Name or description of project, LCP, etc.: Appeal No. A-6-COR-08-098 & 099
(Hotel del Coronado, City of
Coronado)

Re: Hotel Del Coronado Response to Staff Report W8a/b
Appeals A-6-COR-08-098 & 99 (Hotel Del Coronado)

Hotel Del Coronado Response to Staff Report W8a/b
Appeals A-6-COR-08-098 & 99 (Hotel Del Coronado)

EXHIBIT NO. 6
Proposed Structure	APPLICATION NO.
Fault Zone Effect on	A-6-COR-08-98 & 99

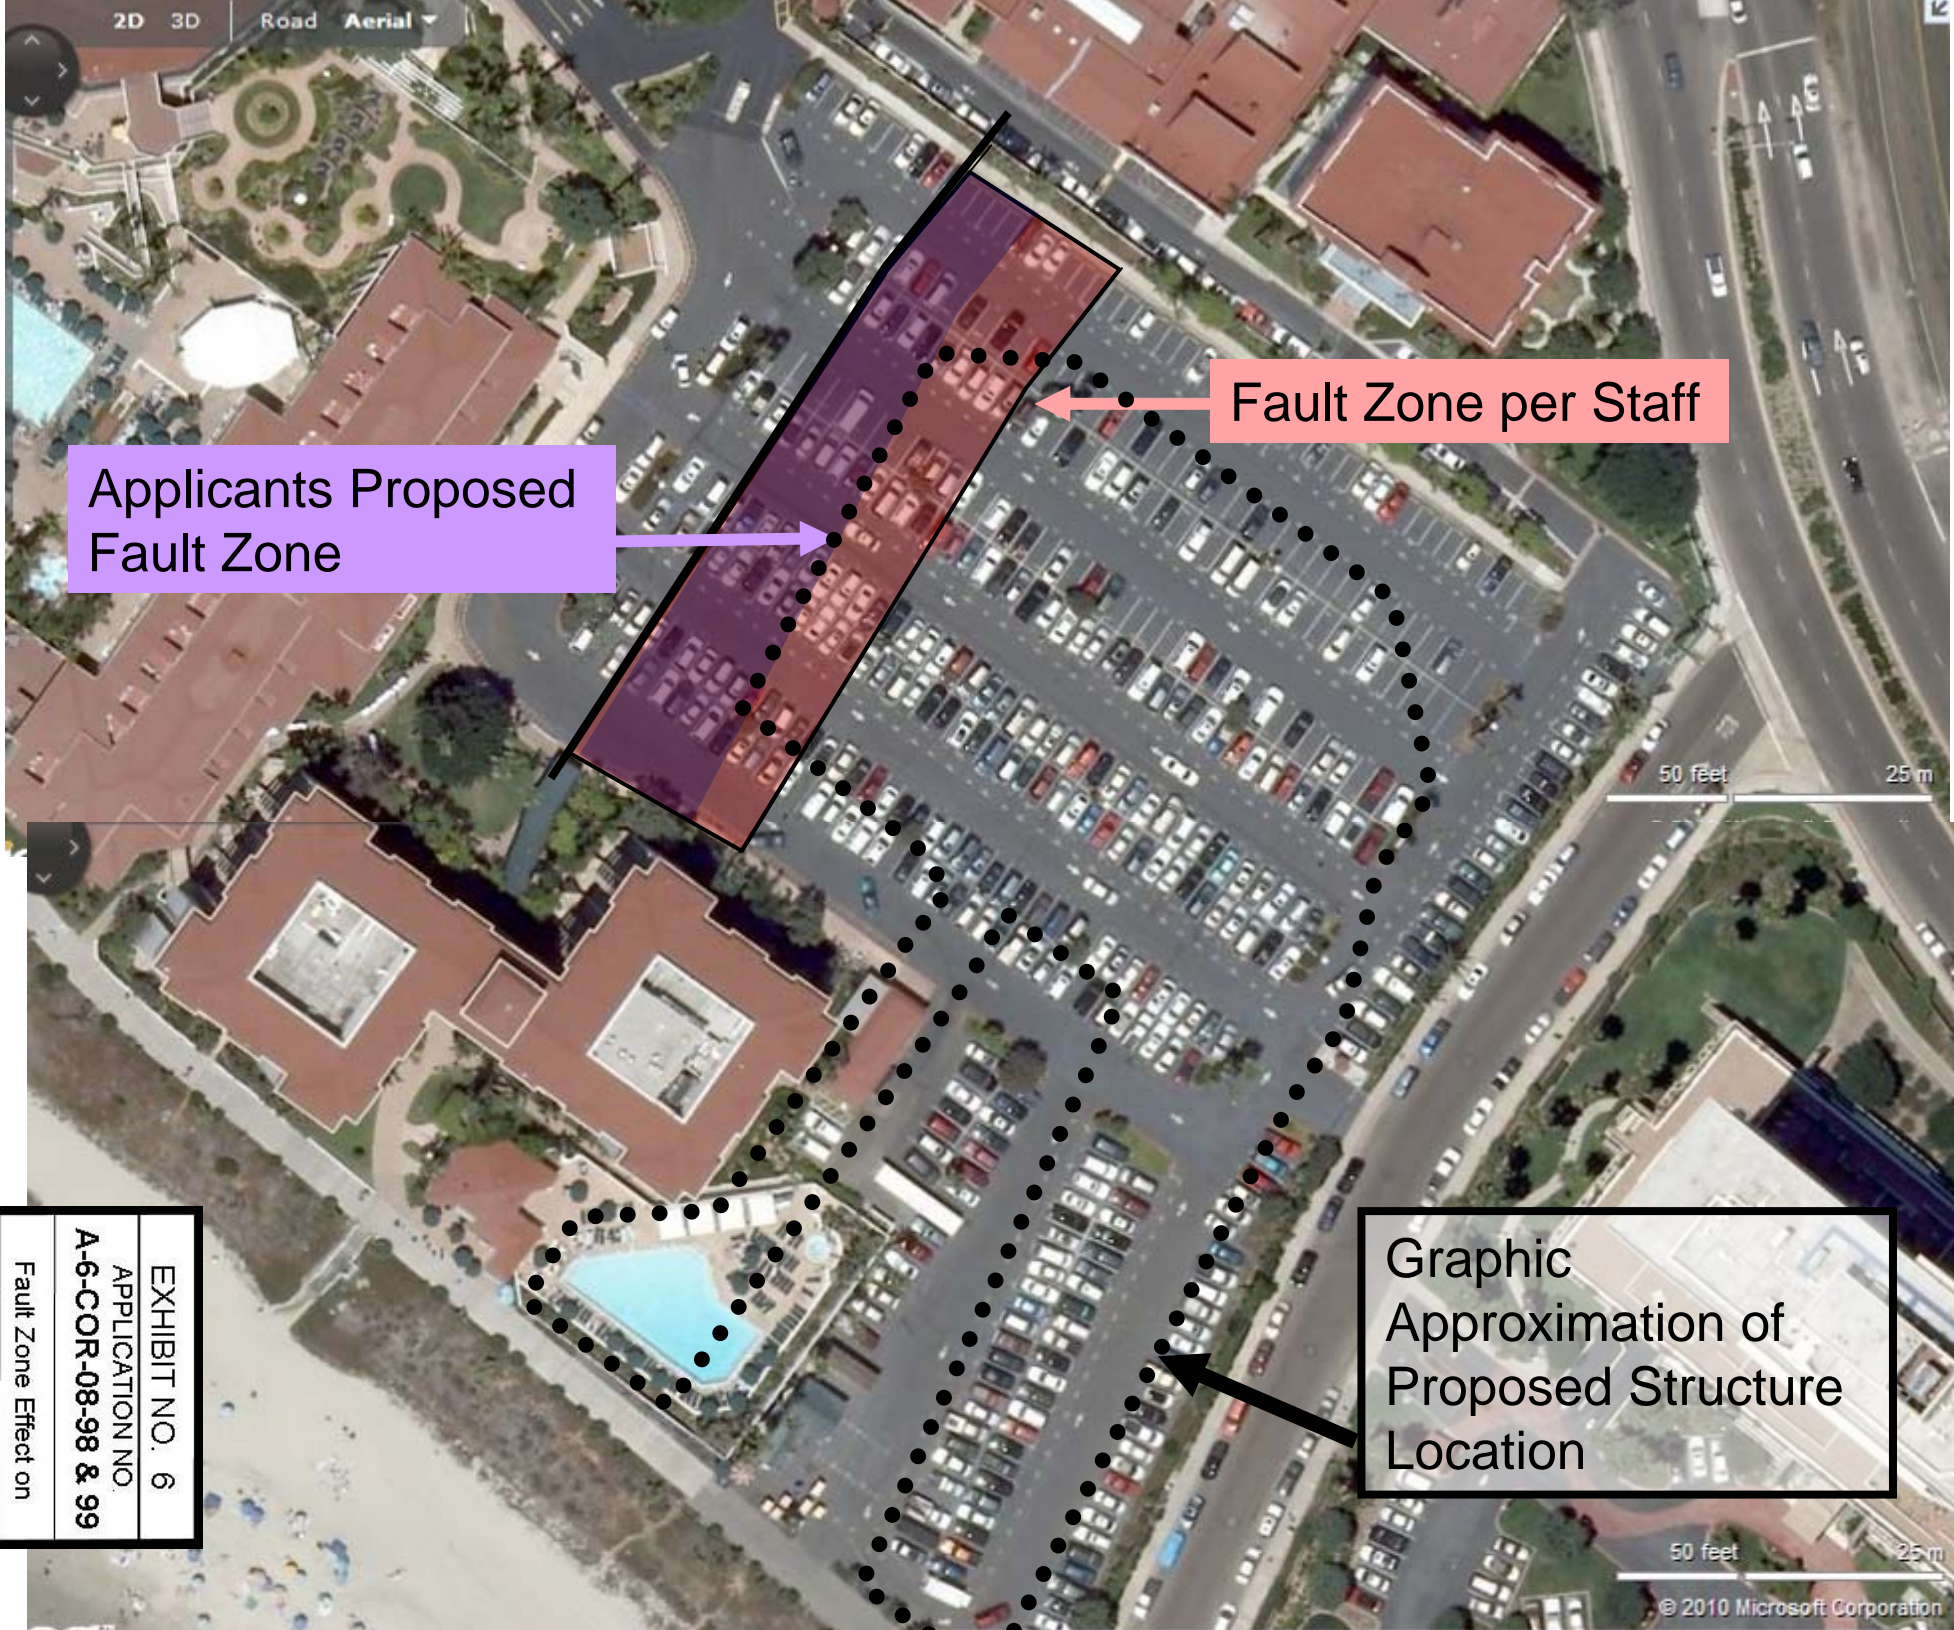
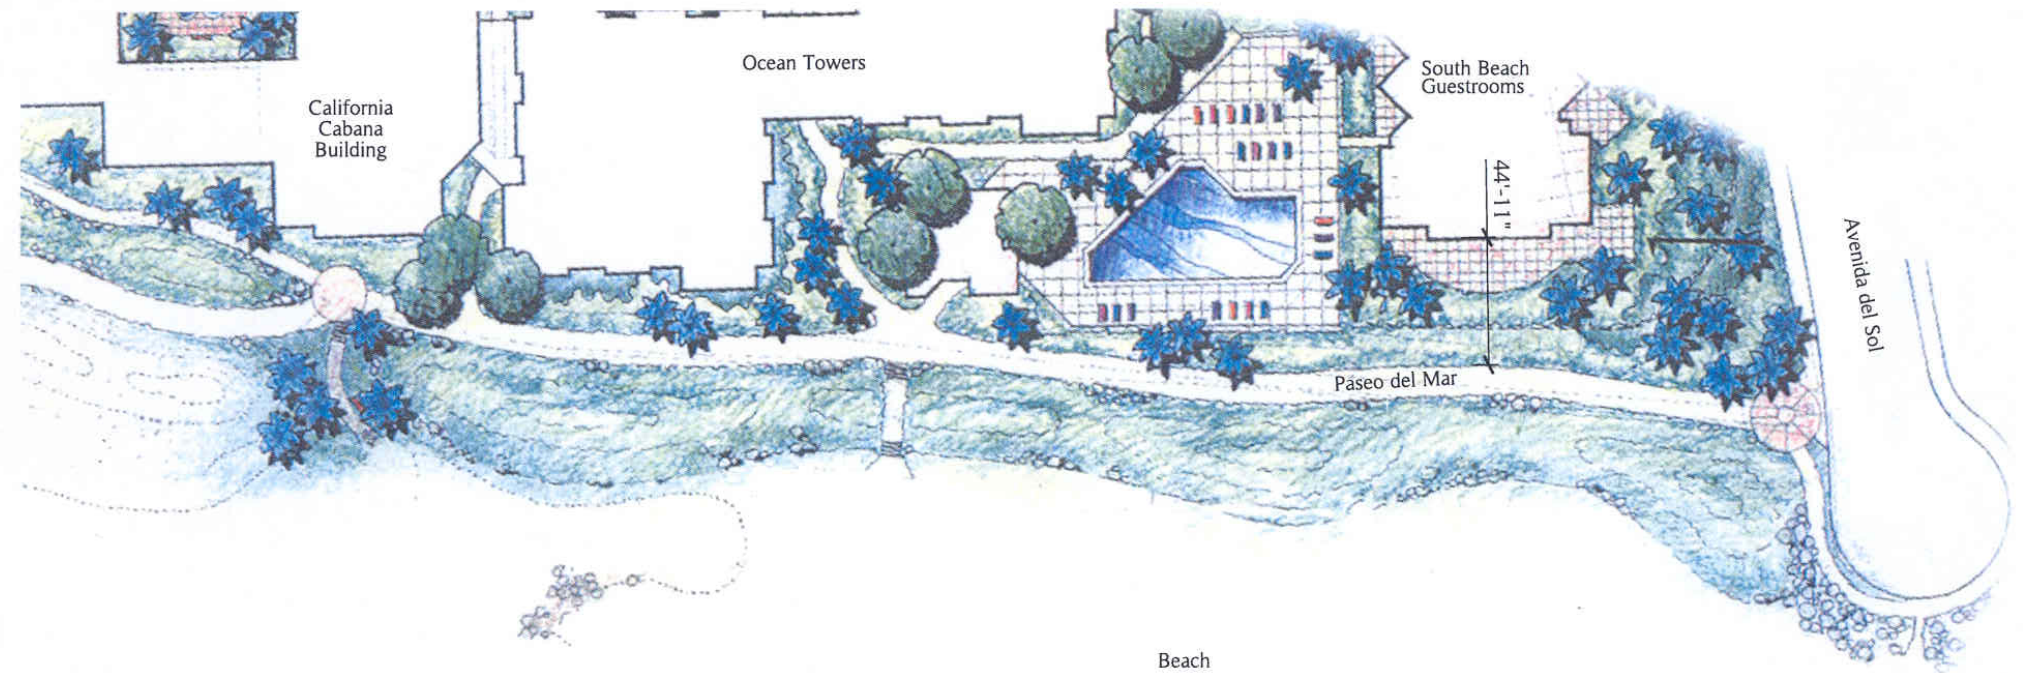
It is our understanding that Geology staff for the California Coastal Commission has suggested a 30-foot increase from the current no build zone, based on concerns at two specific locations- CPT I 24/210 on Line B and CPT 312/314 on Line C. Our previous assessment indicated continuous layers in the Pleistocene age Bay Point Formation between the CPTs in question, as shown on Figures 1 and 2 for Lines B and C respectively. Continuous layers at depth within this formation would indicate an absence of faulting. The Bay Point Formation is estimated to be 200,000 years old based on local paleontology (URS, 2007). Continuous layers indicate the absence of a significant fault that could be active, i.e., a fault that has moved within the past 11,000 years. To further review these locations, the geologic cross sections at the suspected faults were enlarged, as shown on Figures 3 and 4. Review of the areas in question indicates some minor tilting and layer thickness differences in the Bay Point Formation, as noted previously. Layer thickness differences are typical of the various sediment types (sand, silt and clay) comprising the Bay Point Formation. Tilting or warping near the Coronado fault would be expected in the Pleistocene age sediments. However, there are no indications of active secondary faulting.

As mentioned, the original 50-foot no-build zone was modified in January 2010 to provide an increased no-build zone ranging from 55-75 feet across the property. Based on our review, it remains our opinion that the hazard of secondary faulting is low, and is appropriately mitigated by the currently planned setback distance.
